# SERVICE BULLETIN

## INSTALLATION OF 075-17600 TORQUE PLATE SUBASSEMBLY AND 159-03500 DISCS IN PARKER 30-189 BRAKE ASSEMBLY

EFFECTIVITY: All 30-189 brakes that are not to the 30-189A configuration.

REASON: This bulletin provides a procedure for the installation of the 075-17600 Torque Plate Subassembly and 159-03500 Discs in the 30-189 Brake Assembly in place of the 065-15300 Torque Tube, 074-05400 Back Plate Assembly and 159-01300 Discs. This bulletin will allow for the field installation of the Torque Plate Subassembly (P/N 075-17600) and Discs (P/N 159-03500) on a Cessna Model 500, 501, 550 or 551 aircraft for the purpose of improving wear and performance.

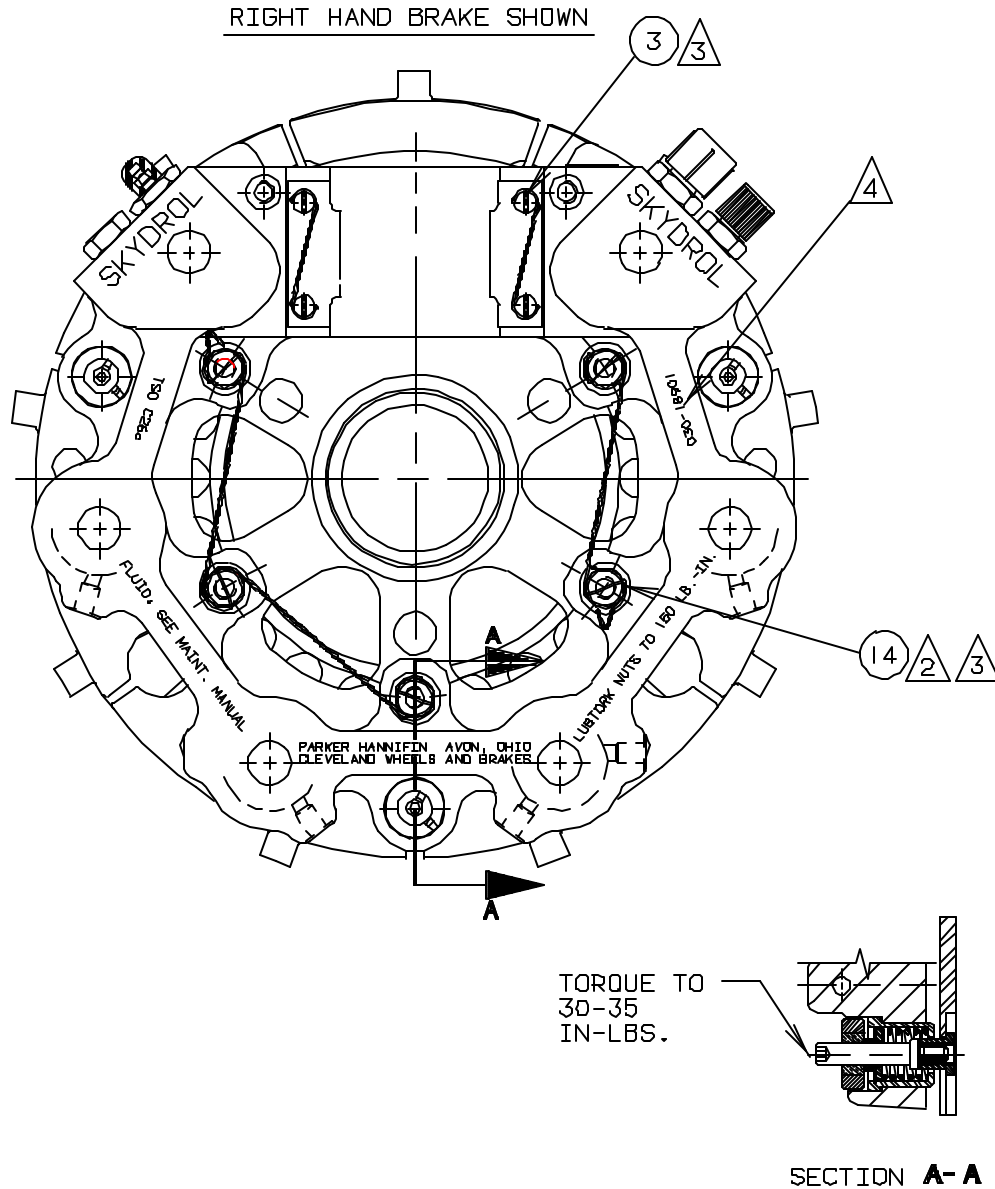
- A. Install Disc (P/N 159-03500), Center Stator Assembly (P/N 242-00700), and Disc (P/N 159-03500) onto 075-17600 Torque Plate Subassembly keeping the wear surfaces oriented as they were on the 065-15300 Torque Tube when removed.

- B. Install Cylinder Assembly (with pressure plate attached) onto the 075-17600 Torque Plate Subassembly, aligning holes with the tapped holes on the lugs of the Torque Plate.

- C. Next, place 095-02800 washer onto the 103-85300 bolt and apply MIL-T-5544B anti-seize compound to both surfaces of washer, under bolt head and threads of bolt. When installing washer onto bolt, the countersink on the washer must face bolt head or bolt failure may result.

- D. Install five (5) 103-85300 bolts thru cylinder into torque plate subassembly, snug down and then final torque 150 lb.-in. and safety wire with MS20995C32 per MS33540.

- E. Test brake in accordance with "Testing Procedure", page 701 of 30-189A Overhaul Manual.
- F. Re-identify brake assembly with new nameplate 166-10800 as follows:

- Model - 30-189A
  - Date Manufactured - (Enter date of manufacture off old nameplate)
  - Serial Number - (Enter serial number of brake assembly)
  - Weight - 35.8#
